HISTORIC AND DESIGN REVIEW COMMISSION

October 4, 2017

HDRC CASE NO: 2017-250
ADDRESS: 1115 NOLAN
LEGAL DESCRIPTION: NCB 1665 BLK 1 17 & W 25 FT OF 16
ZONING: R-6, H
CITY COUNCIL DIST.: 2
DISTRICT: Dignowity Hill Historic District
APPLICANT: Christopher Mongeon
OWNER: Christopher & Lauren Mongeon
TYPE OF WORK: Construction of a two story rear accessory structure, hardscaping, rear yard parking
REQUEST:

1115 Nolan Proposed Work for Backyard and New Structure

Z2017111 Site Plan 1115 Nolan Street

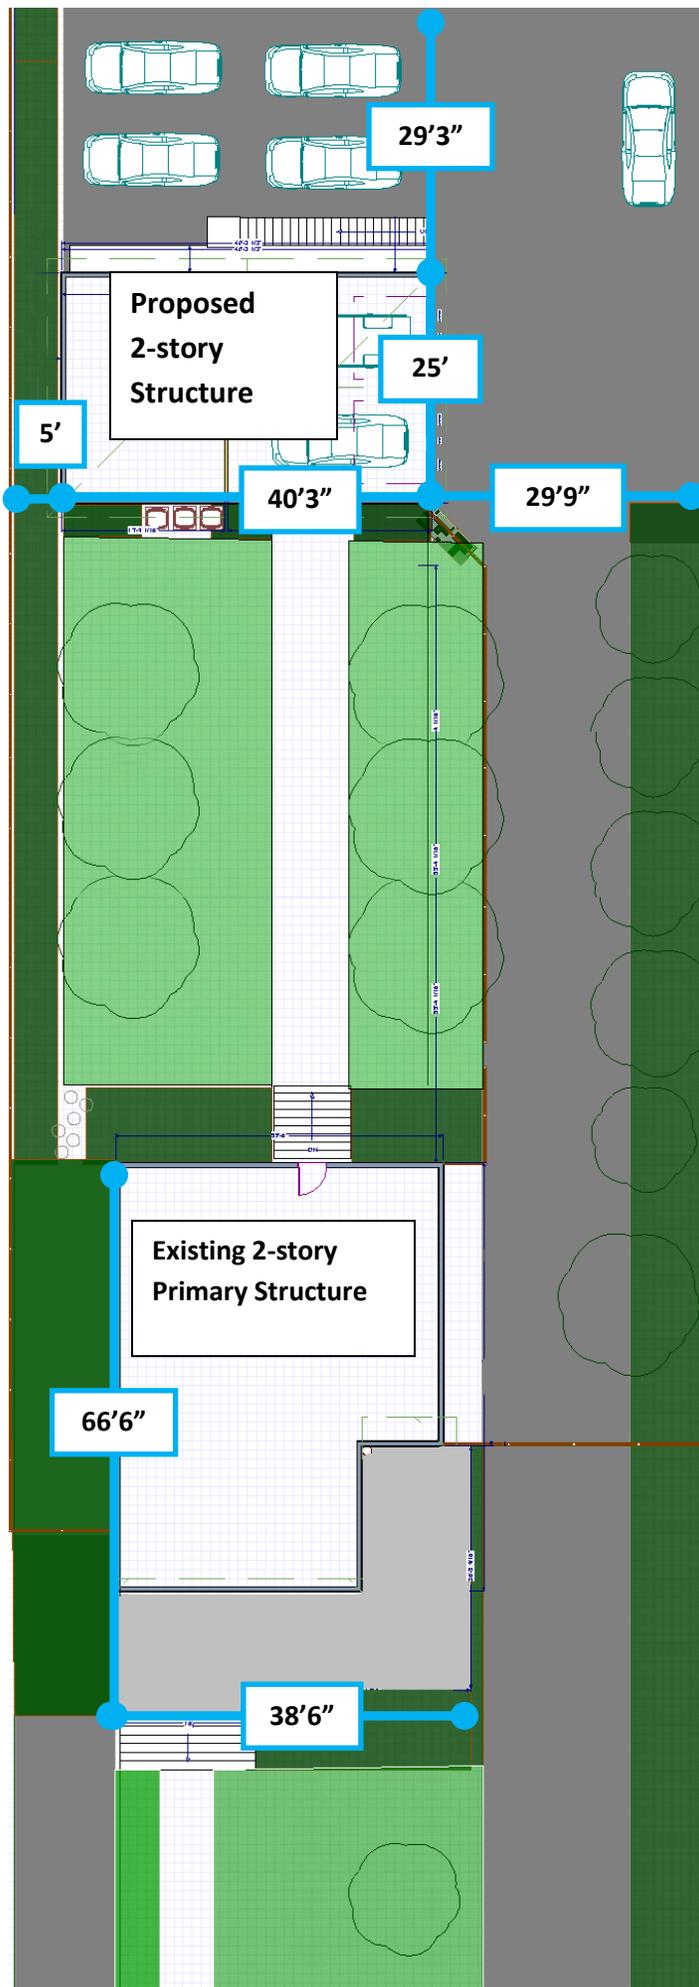
- d. BUILDING SIZE – The Guidelines for New Construction 5.A.ii. notes that new accessory structures should be no larger in plan than forty (40) percent of the primary historic structure’s footprint. Per the applicant’s provided site plan, the proposed structure’s footprint will exceed that which is recommended by the Guidelines. The applicant has proposed a footprint of approximately 1,000 square feet. This is not consistent with the Guidelines. Staff finds that the applicant should reduce the footprint of the proposed structure to be consistent with the Guidelines for New Construction.

- k. REAR YARD PARKING – The Guidelines for Site Elements 7.A.i. notes that the preferred location for on-site parking is at the rear of the site, behind the primary historic structure. The applicant has proposed to locate parking for five (5) automobiles to the rear of both the primary and proposed accessory structure. Staff finds this location appropriate. The applicant has noted that the existing driveway and curbcuts will not be altered.

- ii. That the applicant reduce the footprint of the proposed structure to be consistent with the Guidelines for New Construction.
- iii. That wood or aluminum clad wood windows be installed. White manufacturer's color is not allowed, and color selection must be presented to staff. There should be a minimum of two inches in depth between the front face of the window trim and the front face of the top window sash. This must be accomplished by recessing the window sufficiently within the opening or with the installation of additional window trim to add thickness. Window trim must feature traditional dimensions and an architecturally appropriate sill detail. Window track components must be painted to match the window trim or concealed by a wood window screen set within the opening. Details on each should be submitted to staff for

Elevation View from the East

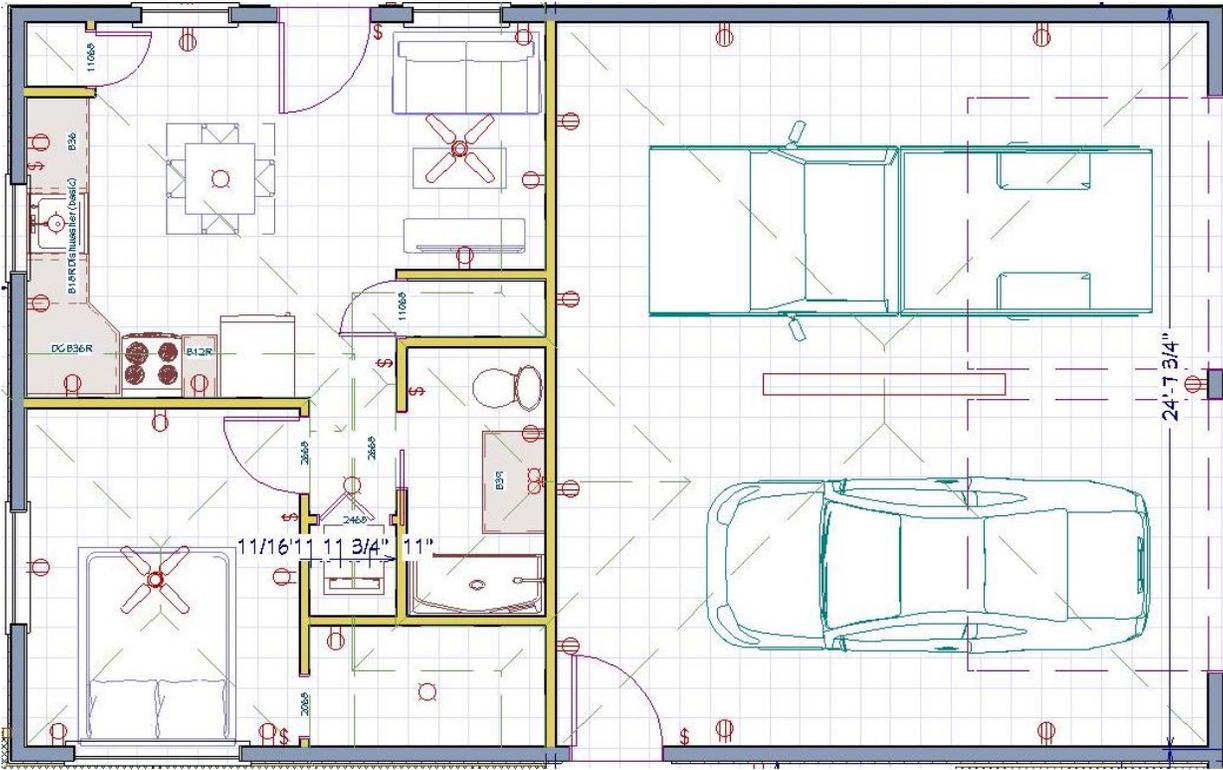
- c. MASSING & FORM – Per the Guidelines for New Construction 5.A.i., new garages and outbuildings should be visually subordinate to the primary historic structure on the lot in terms of their height, massing and form. The applicant has noted an overall height of twenty-seven (27) feet. The primary historic structure features an overall height of thirty-seven (37) feet. Double height accessory structures are not common in the Dignowity Hill Historic District. Staff finds that the construction of a two story rear accessory structure may be appropriate provided that the applicant explore ways of minimizing massing and height to the greatest extent possible. The proposed accessory structure should not be dissimilar to those found historically in the district.

- f. MATERIALS – The applicant has proposed materials which include Hardi board siding, vinyl windows, a standing seam metal roof and two single width garage doors. The applicant has noted that the proposed Hardi siding will feature a smooth finish. Staff finds that the Hardi siding should feature an exposure of four inches. Additionally, the proposed standing seam metal roof should feature panels that are 18 to 21 inches in width, seams that are 1 to 2 inches in height, a crimped ridge seam and a standard galvalume finish. Staff does not find the installation of vinyl windows appropriate. Staff finds that wood or aluminum clad wood windows should be installed. White manufacturer’s color is not allowed, and color selection must be presented to staff. There should be a minimum of two inches in depth between the front face of the window trim and the front face of the top window sash. This must be accomplished by recessing the window sufficiently within the opening or with the installation of additional window trim to add thickness. Window trim must feature traditional dimensions and an architecturally appropriate sill detail. Window track components must be painted to match the window trim or concealed by a wood window screen set within the opening. Details on each should be submitted to staff for review.

- i. That the applicant explore ways of minimizing massing and height to the greatest extent possible to result in a rear accessory structure that is consistent with the historic examples found throughout the district.

- iv. That the proposed standing seam metal roof feature panels that are 18 to 21 inches in width, seams that are 1 to 2 inches in height, a crimped ridge seam and a standard galvalume finish.
